Subject: Duke Energy Carolinas, LLC
Oconee Nuclear Site, Units 1, 2, and 3
Docket Numbers 50-269, 50-270, and 50-287
Proposed License Amendment Request to Revise the Technical Specifications
Pursuant to the Use of Gadolinia Integral Burnable Absorber
License Amendment Request Number 2009-12

Subject: Proposed License Amendment Request to Revise the Technical Specifications
Pursuant to the Use of Gadolinia Integral Burnable Absorber

Figure 1-1

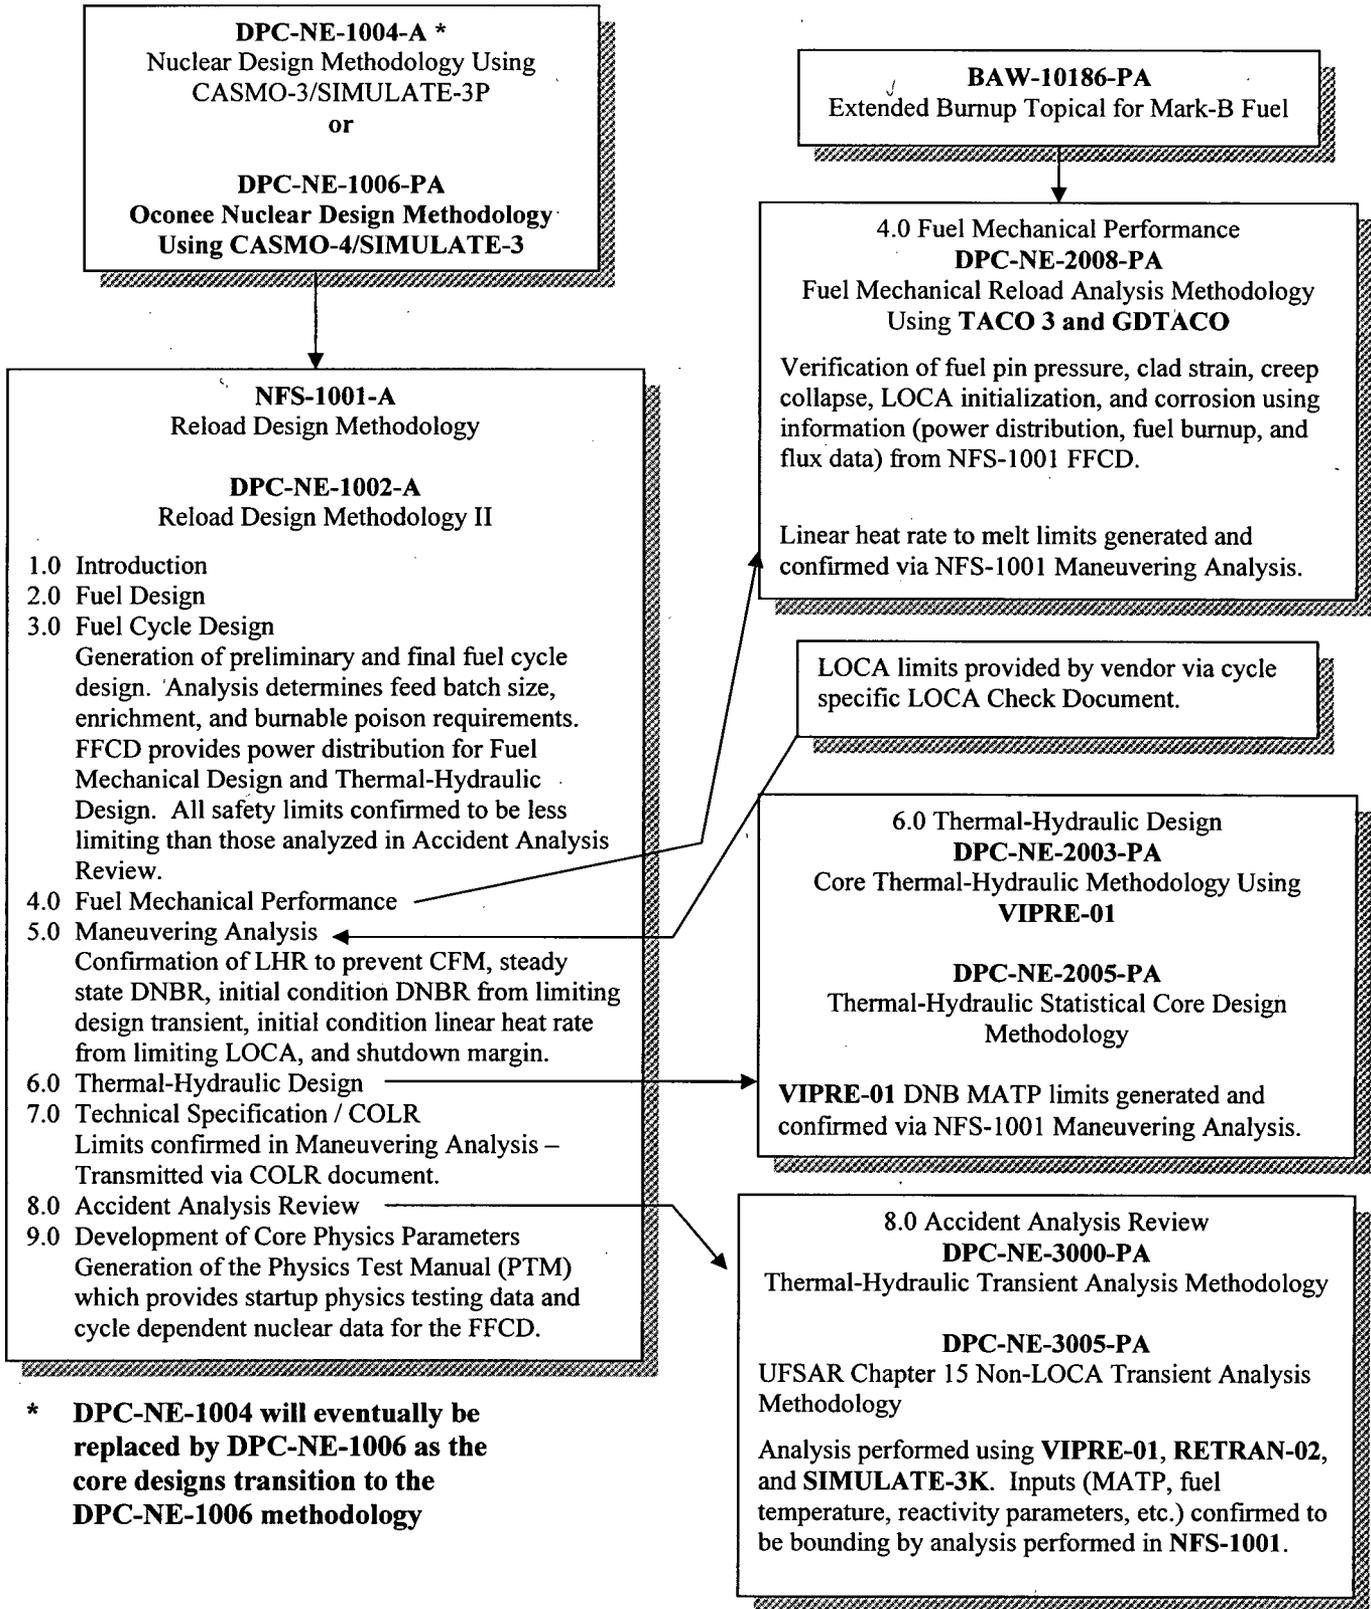
- Figure 1-1 of NFS-1001-A will be revised to add DPC-NE-1006 alongside DPC-NE-1004 and to revise the title of DPC-NE-2008. Additionally, a note will be added to state that DPC-NE-1004 is only included while the core designs transition to DPC-NE-1006.

Oconee core designs are currently performed and will continue to be performed using CASMO-3/SIMULATE-3 methods documented in DPC-NE-1004 until such a time as they can be transitioned to CASMO-4/SIMULATE-3 methods documented in DPC-NE-1006. DPC-NE-1006 describes the CASMO-4/SIMULATE-3 methods that are required for modeling gadolinia fuel. Therefore, reference to both methodologies is made. The title change to DPC-NE-2008 is made to be consistent with the title change to DPC-NE-2008 as submitted with the LAR.
